ABERDEEN SCHOOL DISTRICT #5
Aberdeen School District Capital Projects 2026

410 North G Street
Aberdeen, WA 98520

INDEX TO ADDENDUM 1:

A2.04

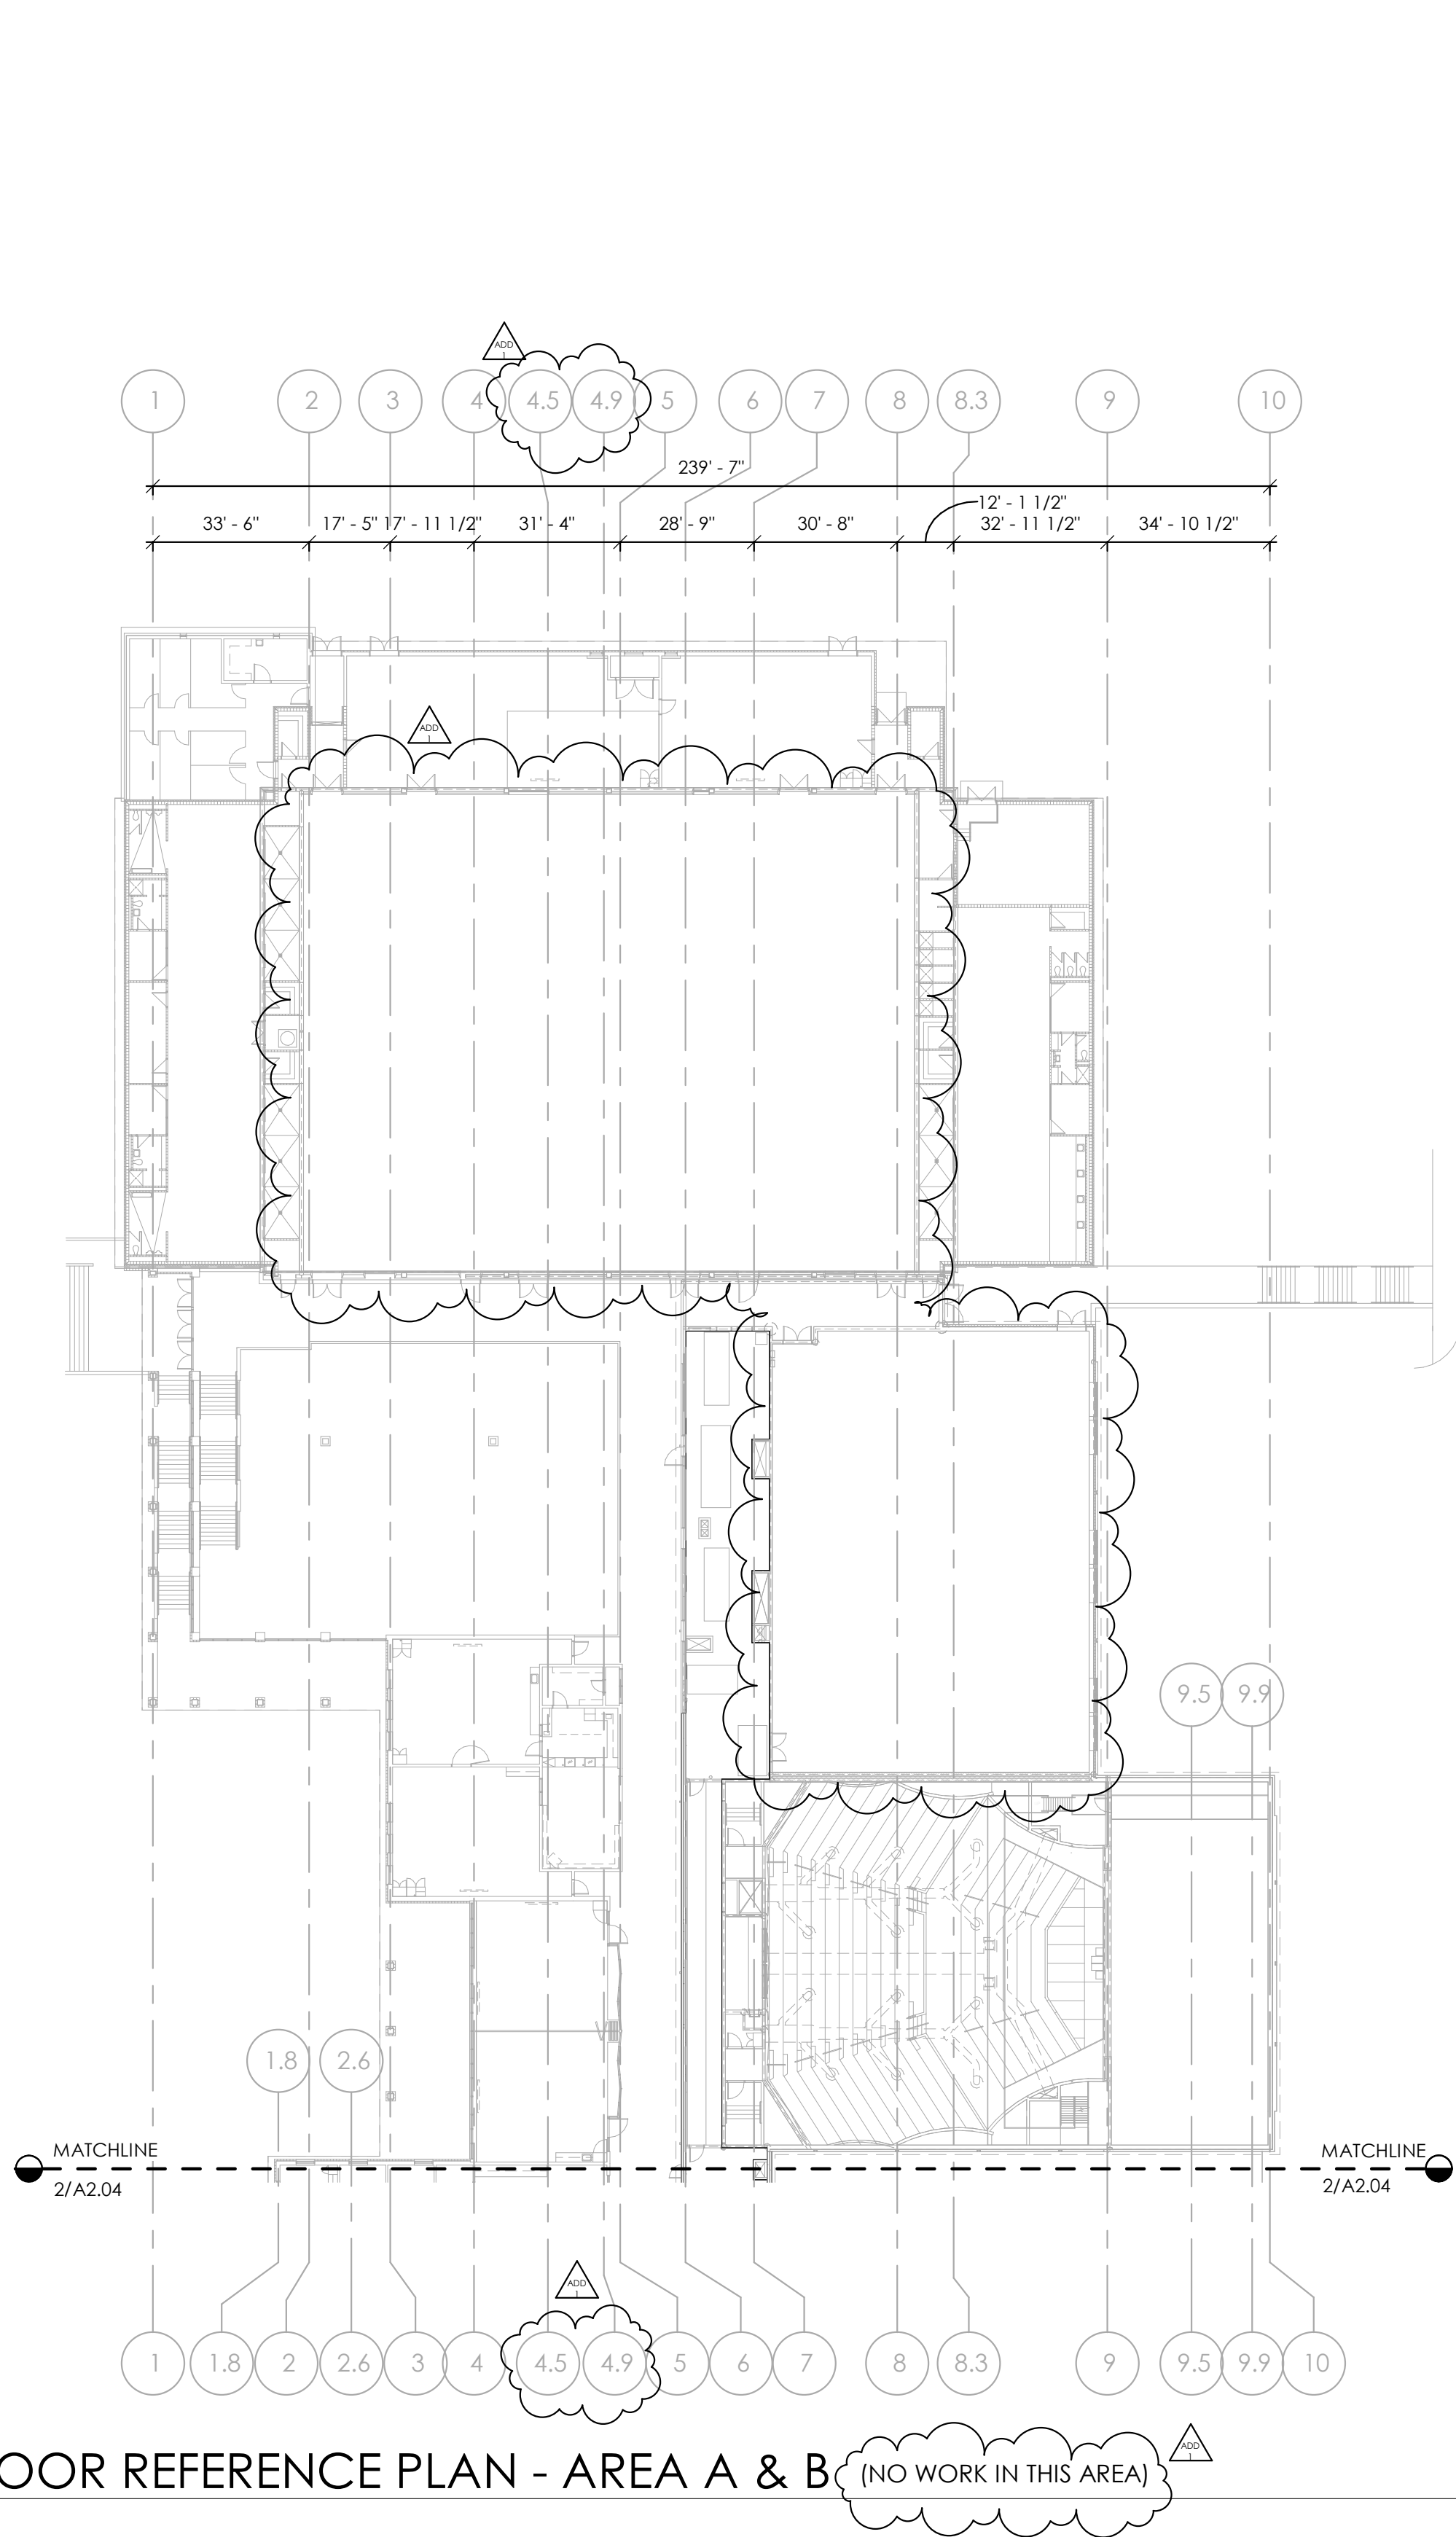
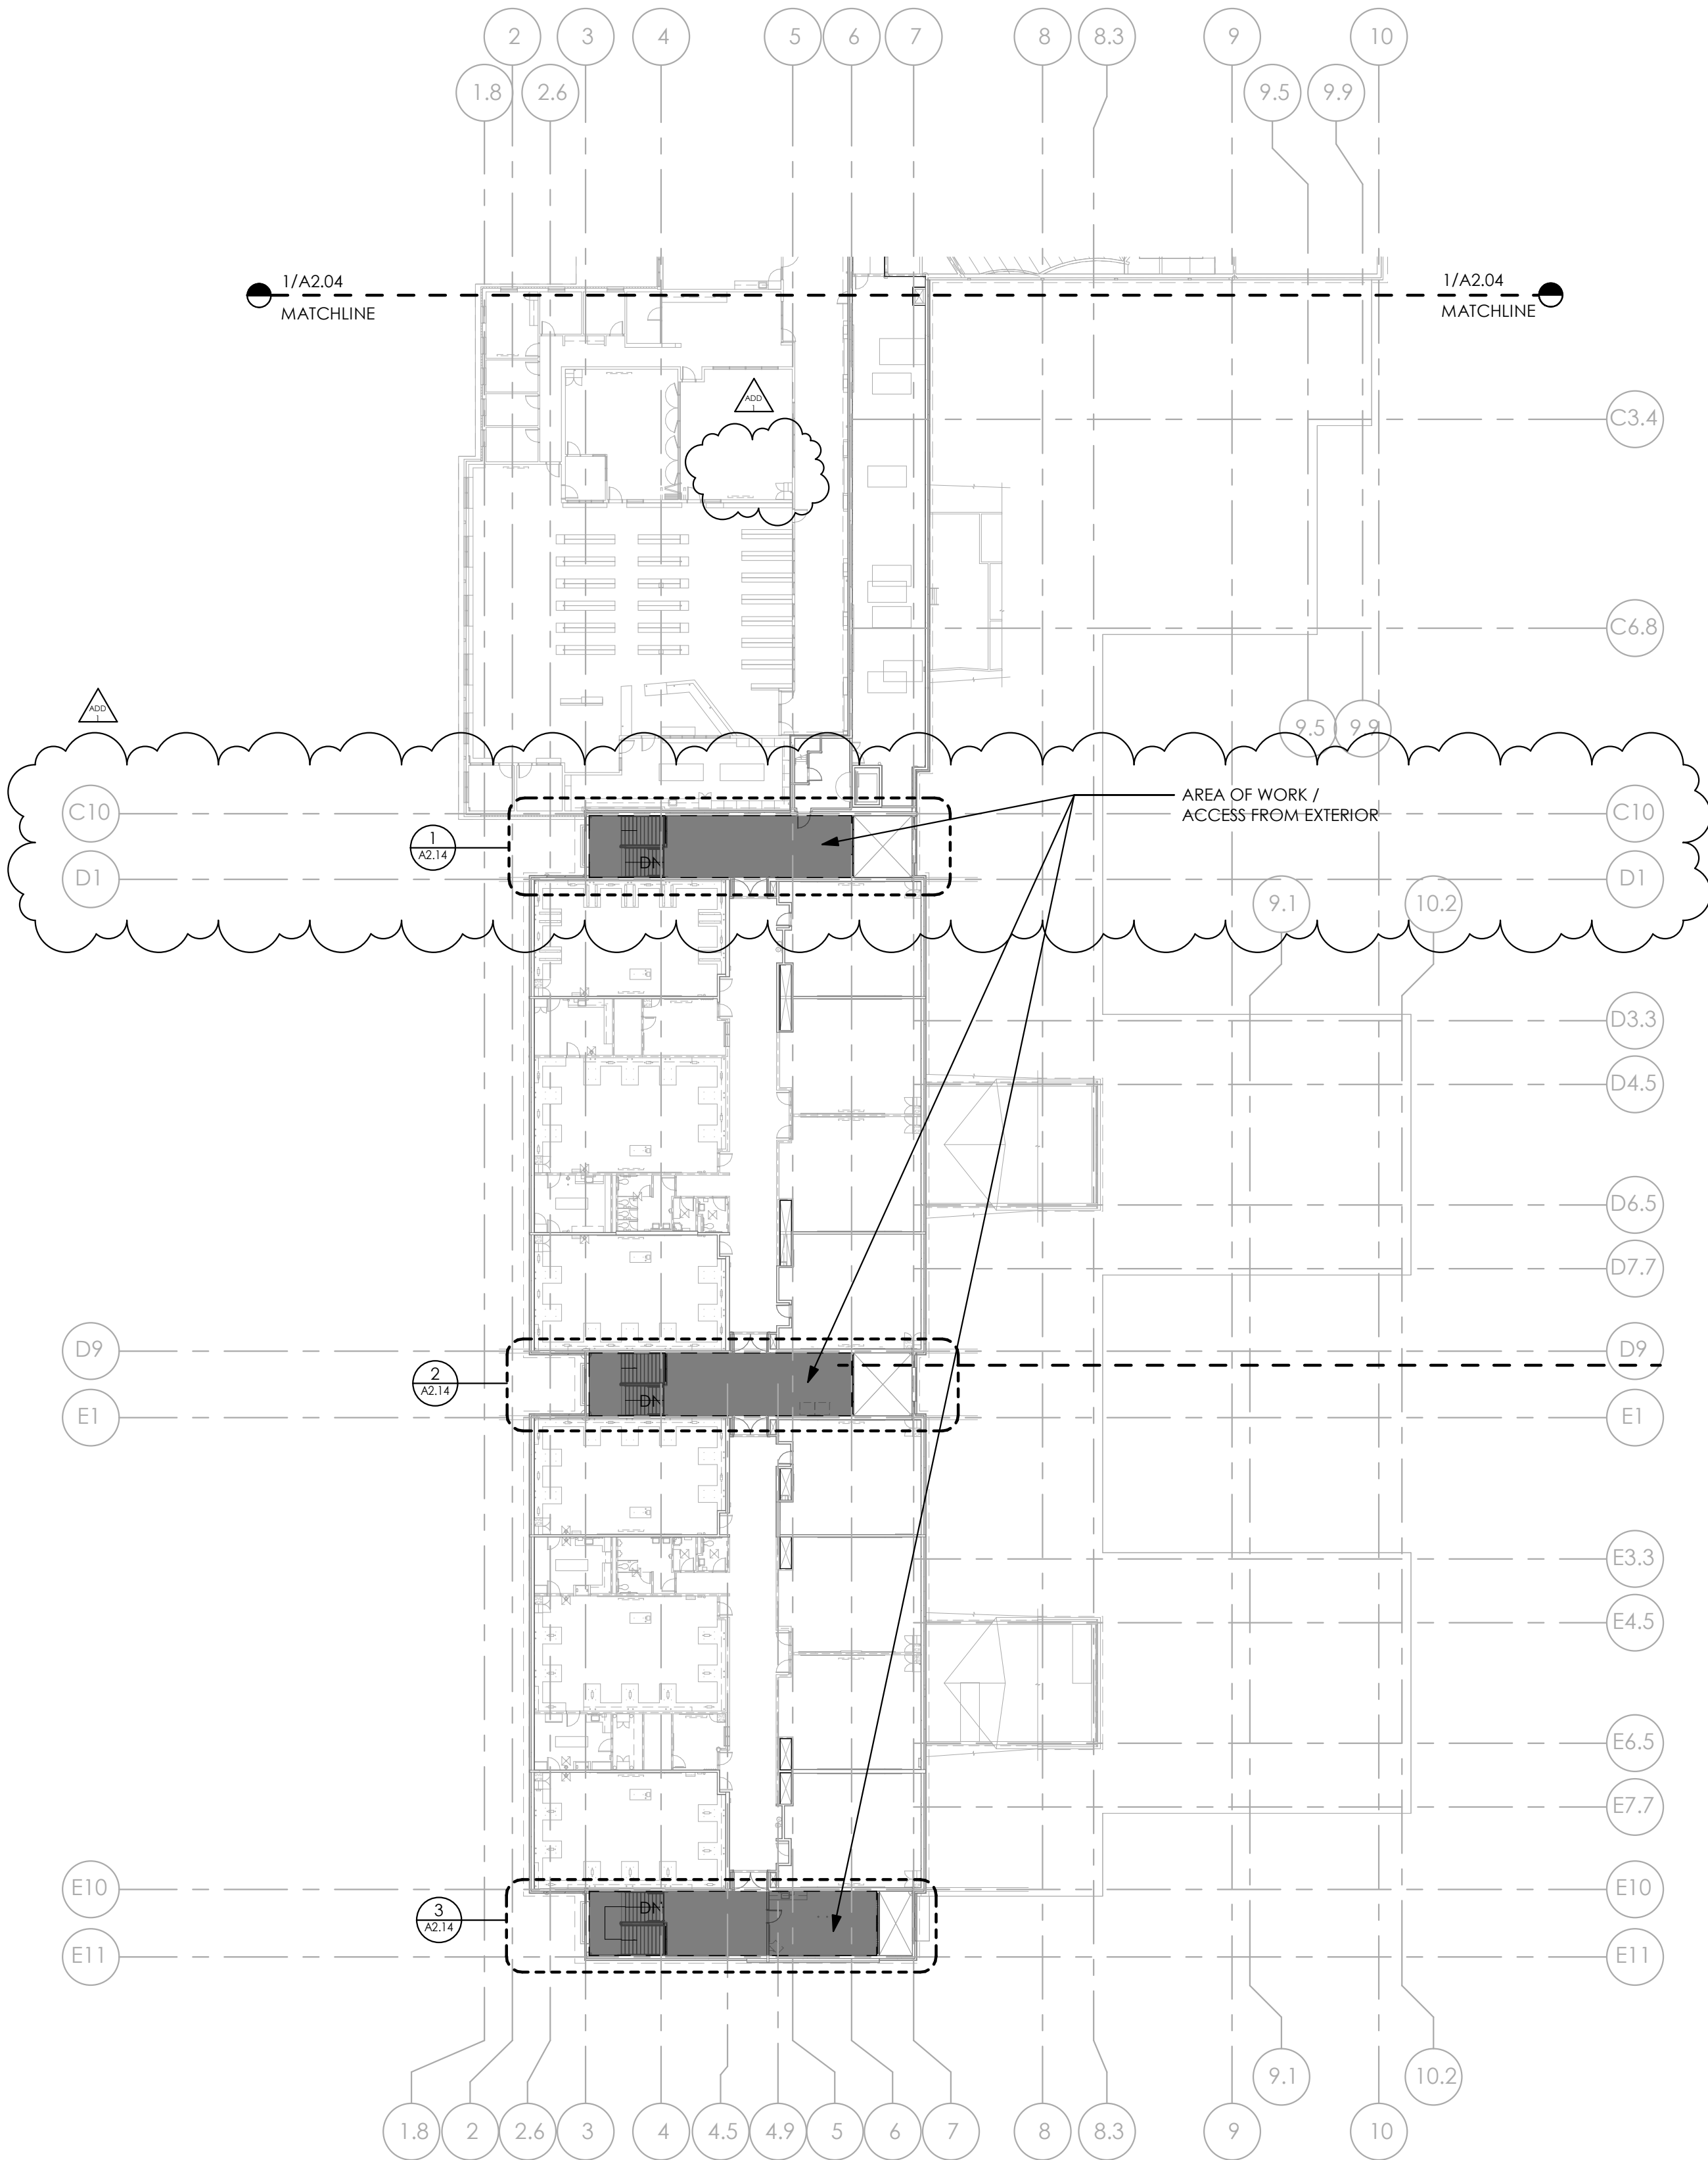
1. Sheet **G3.01**, REVISE note 3) under 'SCOPE OF THIS PROJECT' to read, **EXISTING SAWDUST COLLECTION SYSTEM REPLACEMENT WORK OCCURRING CONCURRENTLY UNDER SEPARATE GENERAL CONTRACT, COORDINATE DEMOLITION AND INSTALLATION WINDOWS WITH SEPARATE CONTRACTOR.**
2. REPLACE sheet **A2.02** in its entirety.
3. REPLACE sheet **A2.04** in its entirety.
4. REPLACE sheet **A2.11** in its entirety.
